HARYANA POWER GENERATION CORPORATION LIMITED
Regd. Office – C-7, Urja Bhawan, Sector-6, Panchkula
Corporate Identity Number: U45207HR1997SGC033517
Website: www.hpgcl.org.in E-mail- ceplg@hpgcl.org.in

CORRIGENDUM-3

The amendments and clarifications regarding Bidding document no. 32/CE/PLG/DCRTPP/FGD-251 (Tender ID: 2023_HBC_308422_1) for Wet Limestone based FGD System Package for DCRPP, Yamunanagar (2x300MW) in respect of queries raised by the bidders are attached as Annexure-A (Amendments) and Annexure-B (Clarifications) respectively.

**FGD System Package for DCRTPP, Yamunanagar (2x300 MW)
Bidding Document No: 32/CE/PLG/DCRTPP/FGD-251
Amendment No: 32/CE/PLG/DCRTPP/FGD-251-Amndt.-01**

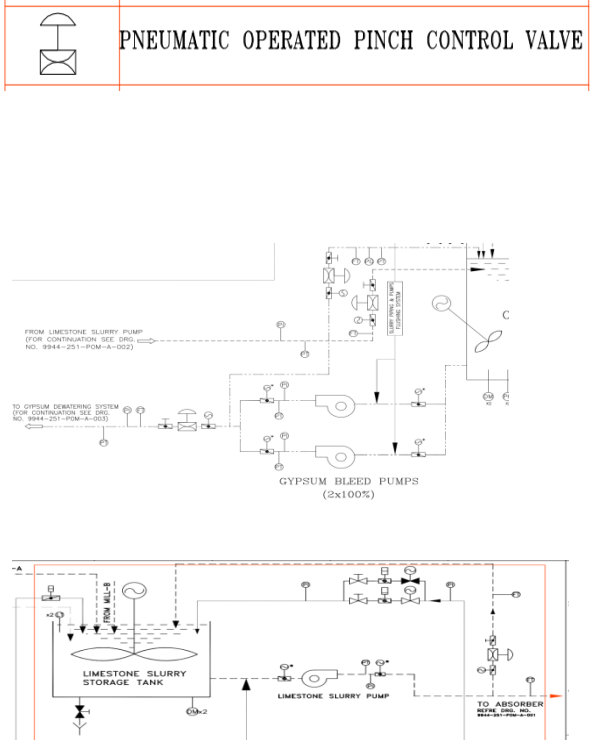
39.	VI/B I-M1		5.06.06	17/52	Mist Eliminator: Three stage chevron type Mist Eliminators (ME) made of Polysulfone or stainless steel shall be provided at the exit of the absorber.	We recommend ME made of PP (Polypropylene) as per manufacturer's standard and proven practice and which are installed in many FGD plants around the world and	Bidder to comply the specification requirement.

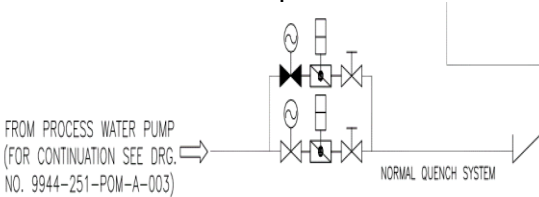
49.						Optimizing Maximum Auxiliary Power Consumption: Considering the existing maximum auxiliary power consumption allowances for the Yamuna Nagar (2x300=600 MW) and Hisar (2x600=1200 MW) projects are 6.6Kw and 11.4KW respectively, which currently represent 1.1% and 0.95% of actual power consumption respectively, we believe these allowances are exceptionally restricted	Provision of the bidding documents shall prevail.

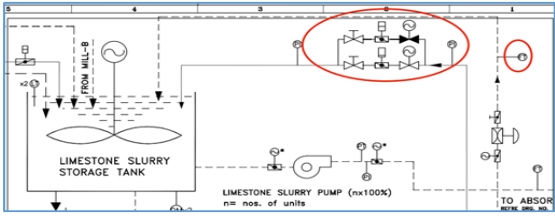
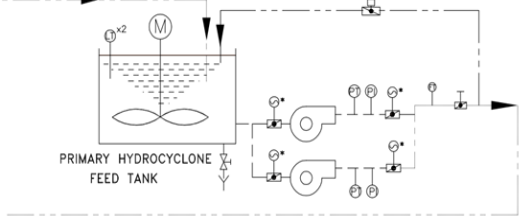
54.	SECTION-VI PART A PART E	SUB-SECTION-III A1 (FGD) Scheme of Gypsum	5.04.00	5 of 10	The filtrate water from belt filter dewatering and wash water from washing system and the underflow from the secondary hydro-cyclone shall be taken to a common filtrate water tank. 2x100% pump shall be provided to supply wash water (for cake washing as well as belt	Bidder would like to inform that Filtrate water is not suitable for cake washing and belt cloth washing. Clarified water shall be provided for cake washing as per clause no. 7.04.07 mentioned in Technical Specification Section-VI Part	Bidder to refer Note-2 of the drawing no. 9944-251-POM-A-003 i.e. Arrangement for Cake and belt/cloth washing system indicated is typical.

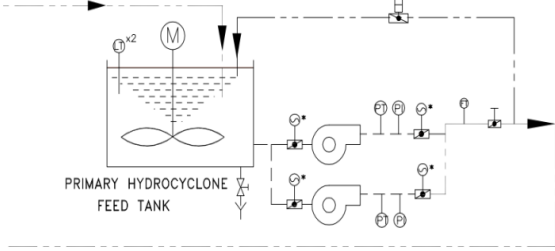
56.	SECTION-VI PART B PART E	SUB-SECTION-I M1 (FGD) Scheme of Gypsum Dewatering Drg no. 994-251-POM-A-003 (Rev A)	7.06.02	28 of 52	2x100% horizontal centrifugal pumps shall be provided for wash water requirements of belt filter

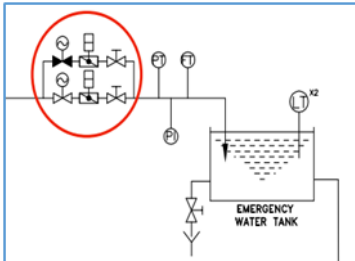
73.	SECTION-VI PART E	Scheme of FGD absorber			<p>Inlet duct scheme for two (2) Booster Fans in parallel for each unit.</p>	<p>Bidder would like to inform that with two(2) parallel booster fan system, each connected with each of 2x300</p>	<p>Bidder to comply the specification requirement.</p>

Sr.no	Specification Reference				Specification requirement	Bidder's query	HPGCL reply
	Section	Sub section	Clause	Page			
		system Drg no. 994-251-POM-A-001 (Rev A)				MW unit, interconnection at inlet is not considered between booster fan suction for criss-cross operation. Bidder envisages that tapping point location and interconnection duct arrangement will give rise to dead zone, and cause condensation of acid and subsequent corrosion issue. Bidder request owner to kindly review this requirement carefully from O&M point of view, and eliminate the interconnection at inlet between two fans.
